# Temperature sensors on APAs

IFIC-Valencia

# Introduction

# Problem 7: Cable length

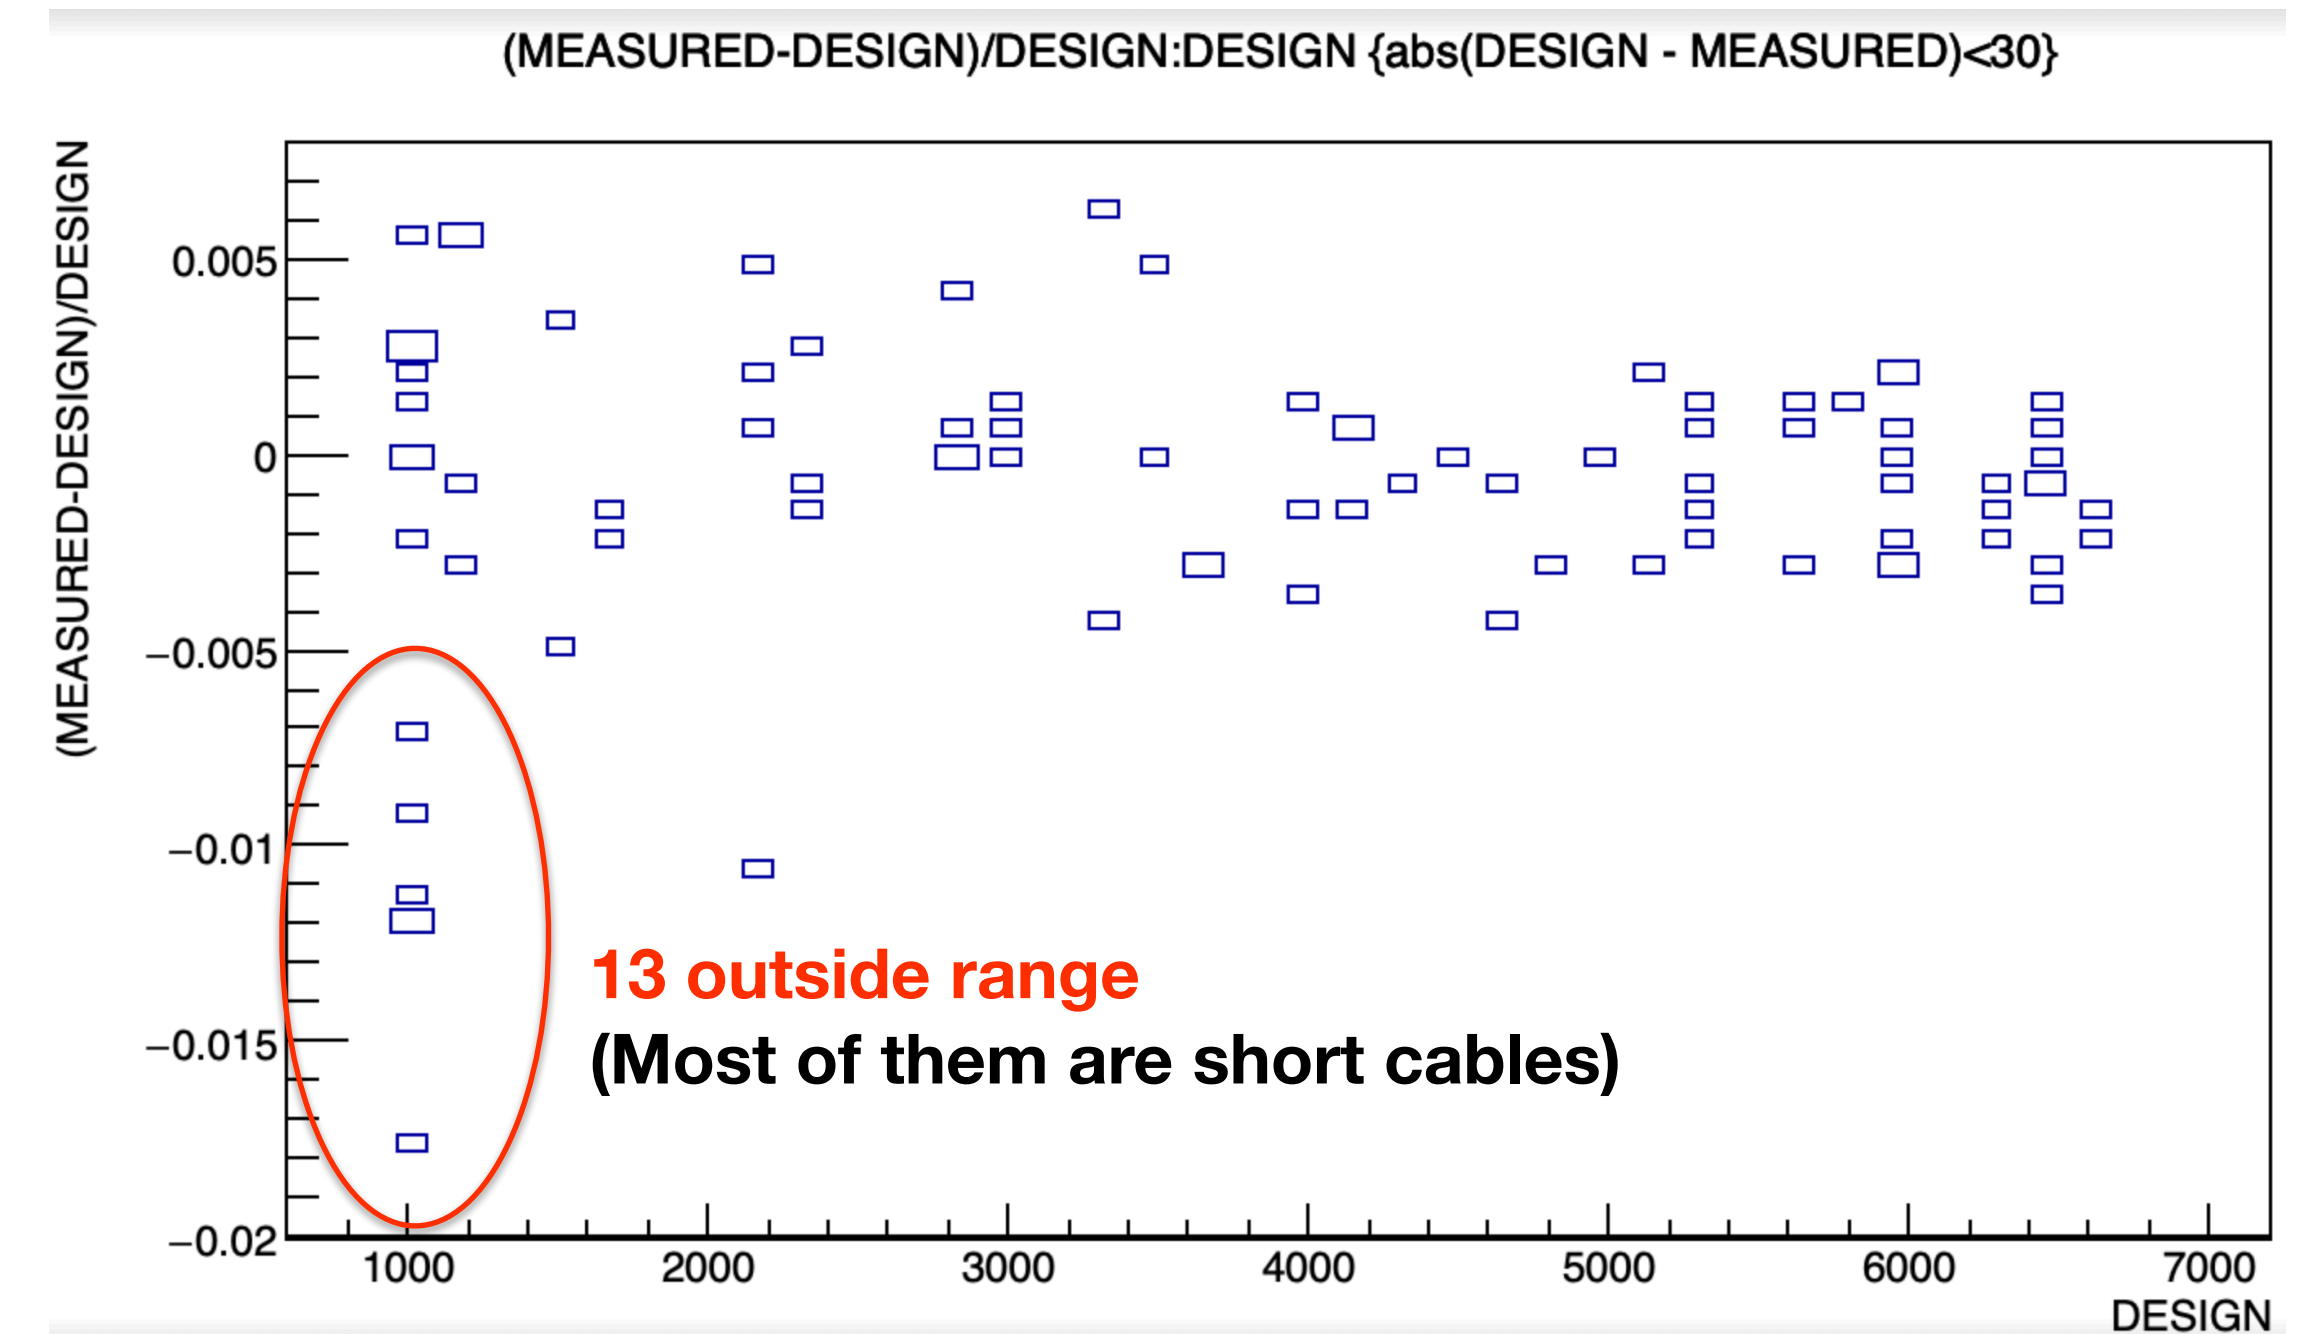
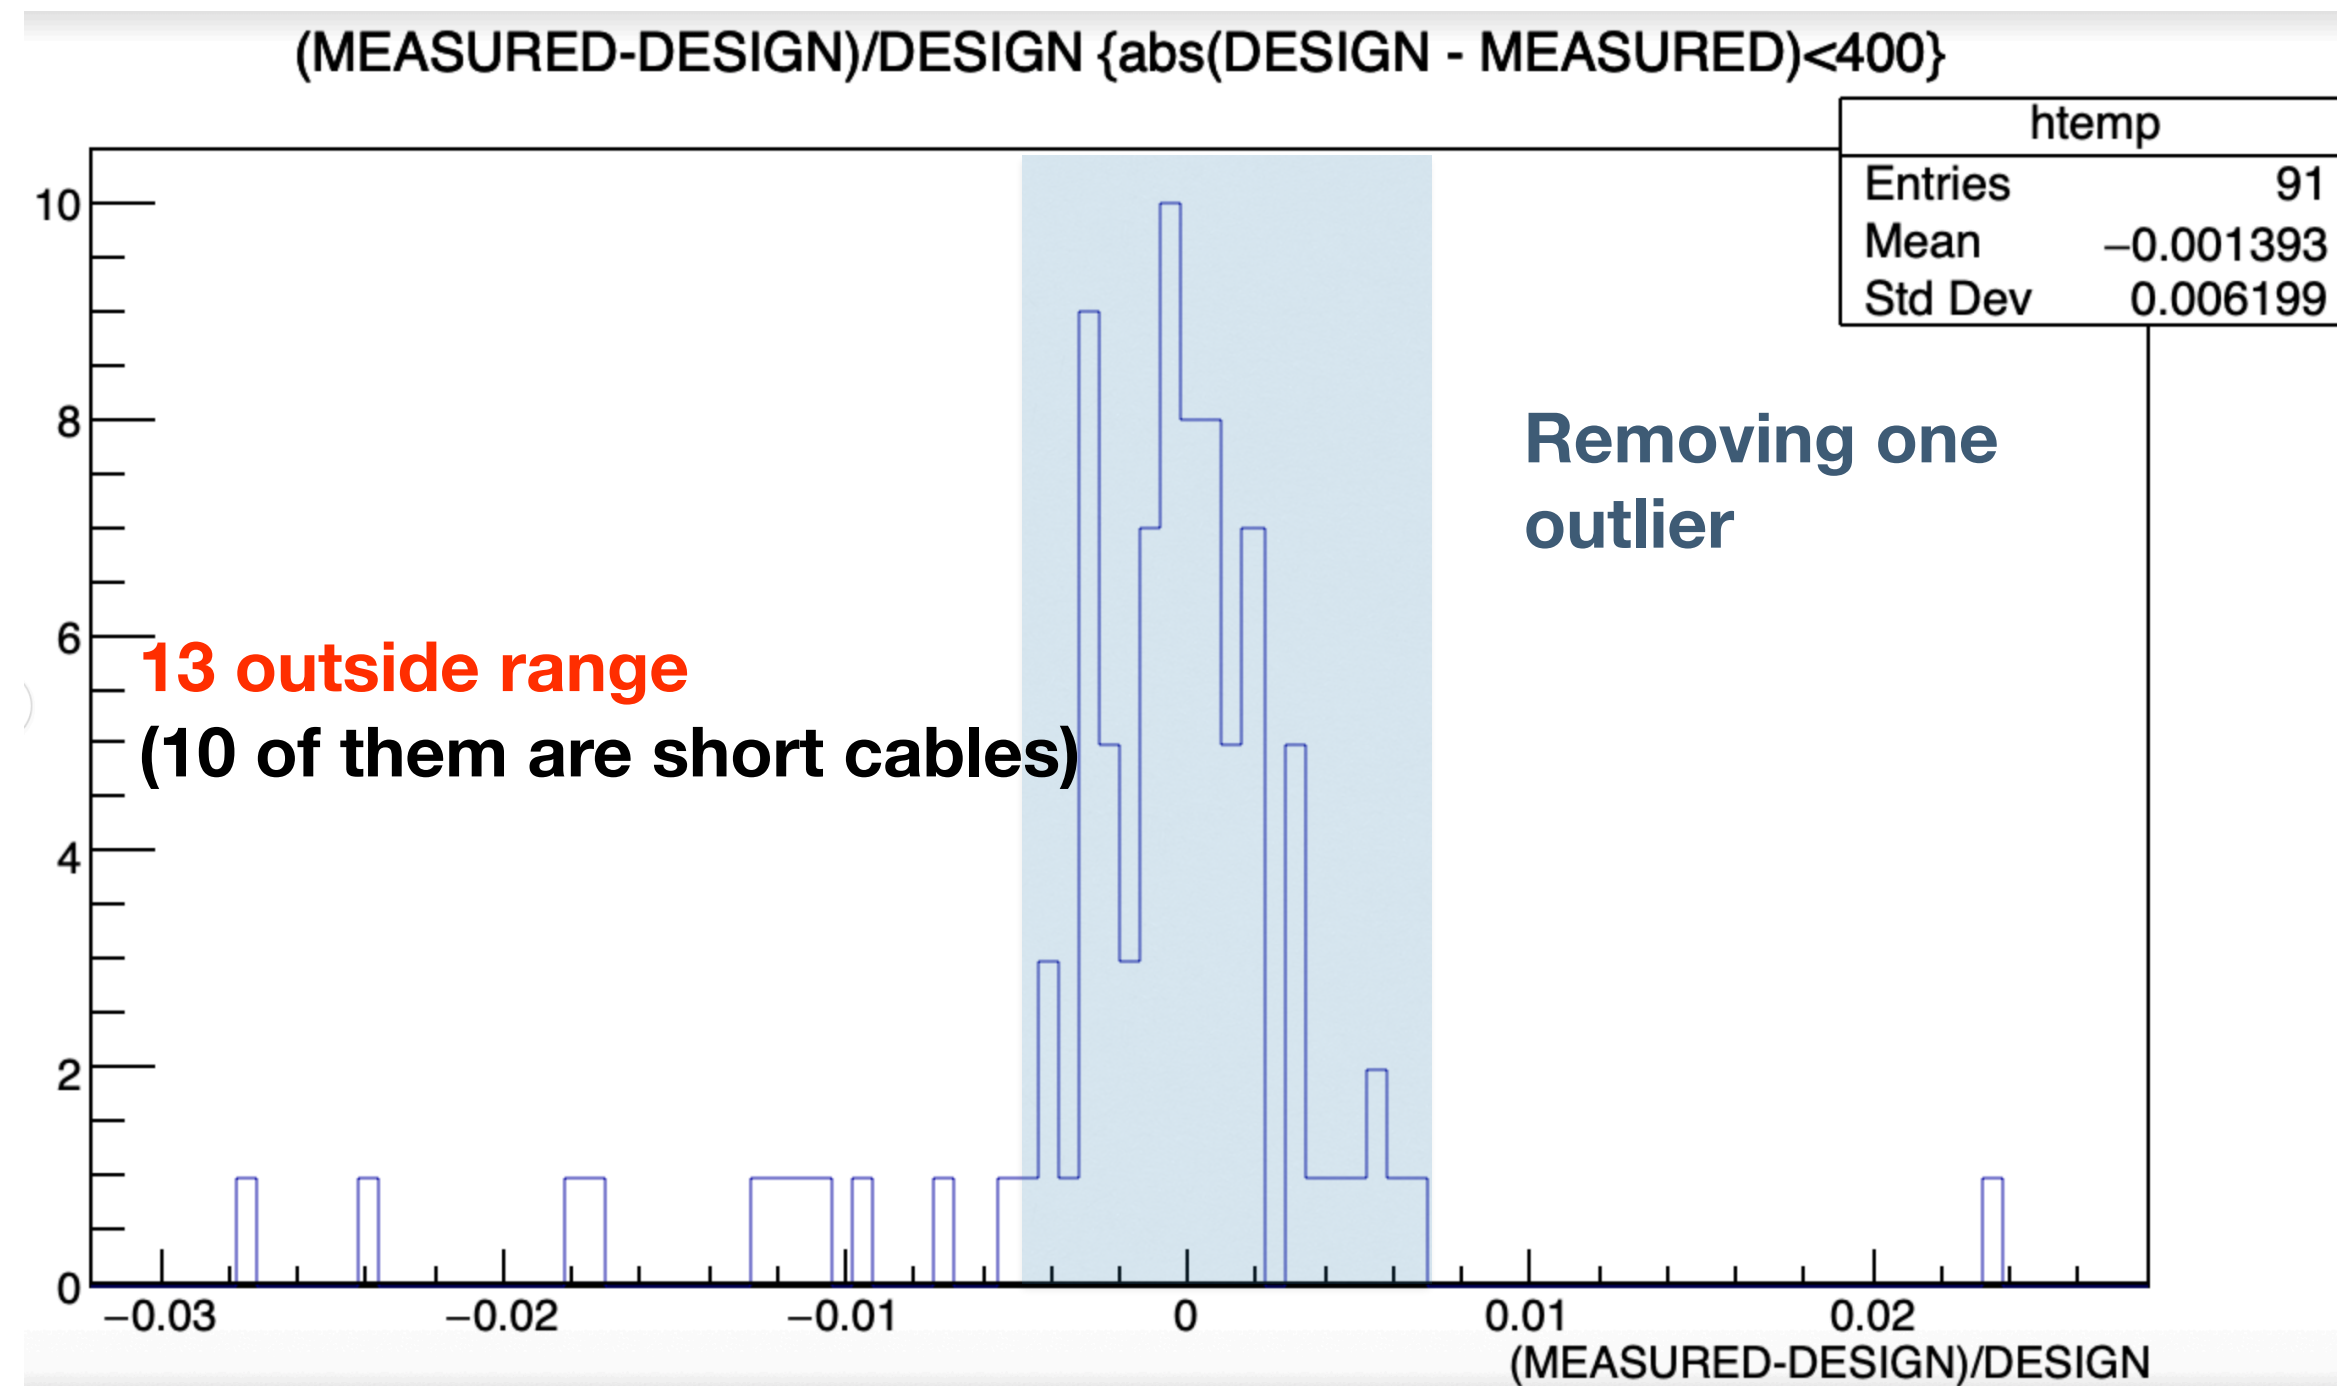
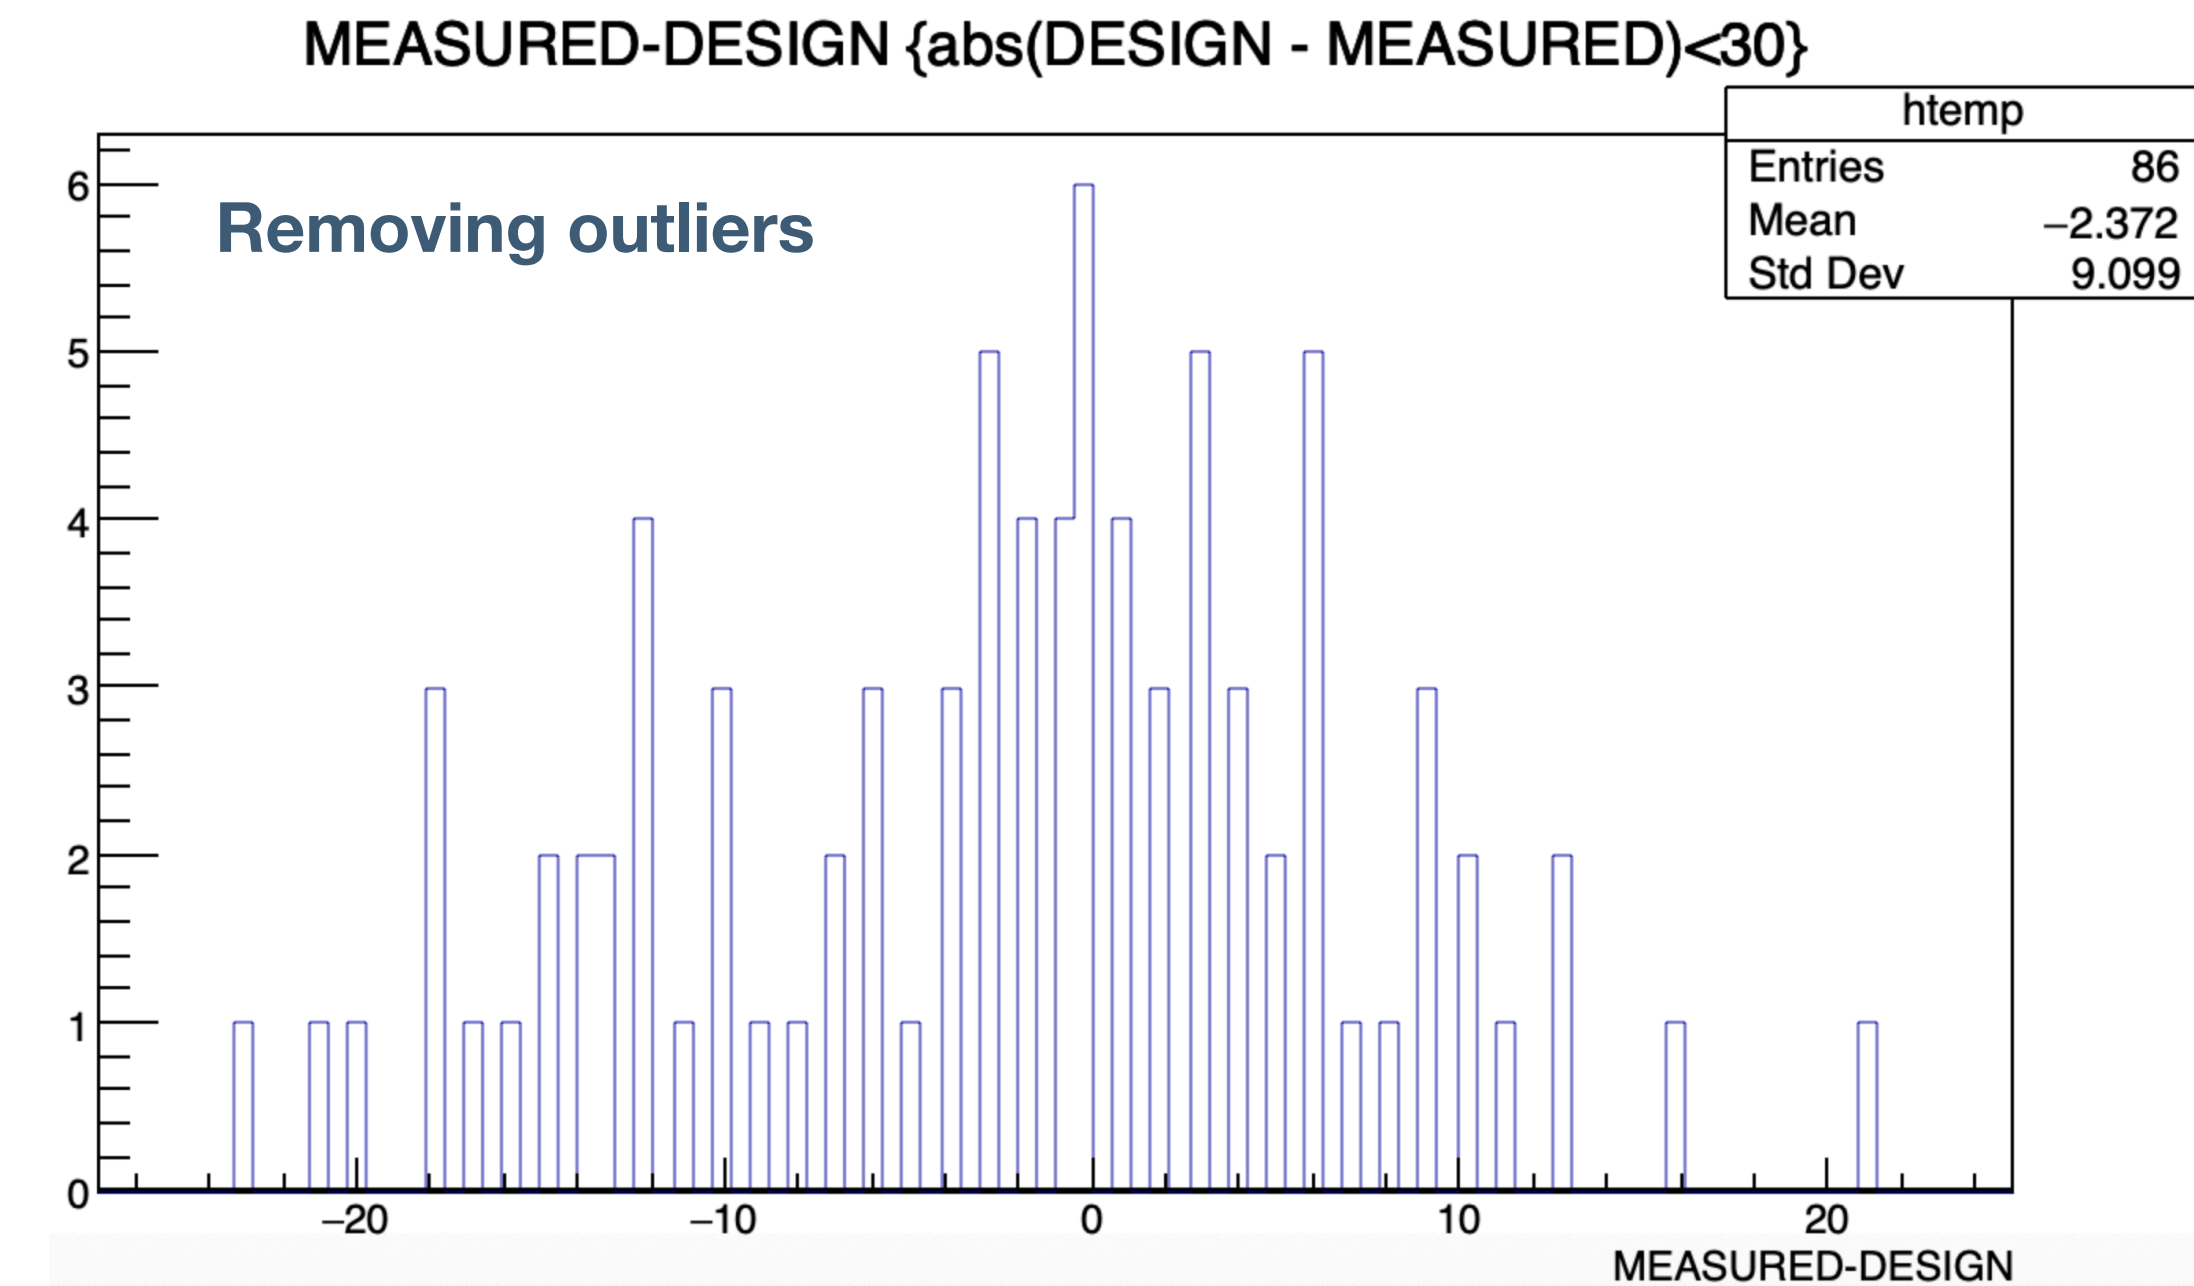
- Cables have 2% slack to account for contraction in cold
- When cutting, we used a 10m long tape measure on the floor
  - 0.5% tolerance is allowed
- We have cross-checked the lengths of 23 APA kits. Results available [here](#)

- 9 mm standard deviation on absolute length (removing outliers)
- This can be easily improved with a laser distance meter and better fixing tools

- Insufficient QC for cable lengths
- **Repair:** redo cables with lengths outside allowed range
- **Changes in production:** use a laser distance meter and proper fixing tools
- **Changes in QA/QC:** measure cables at several stages during production
  - When cutting them
  - After connectorising
  - Before packaging for shipment
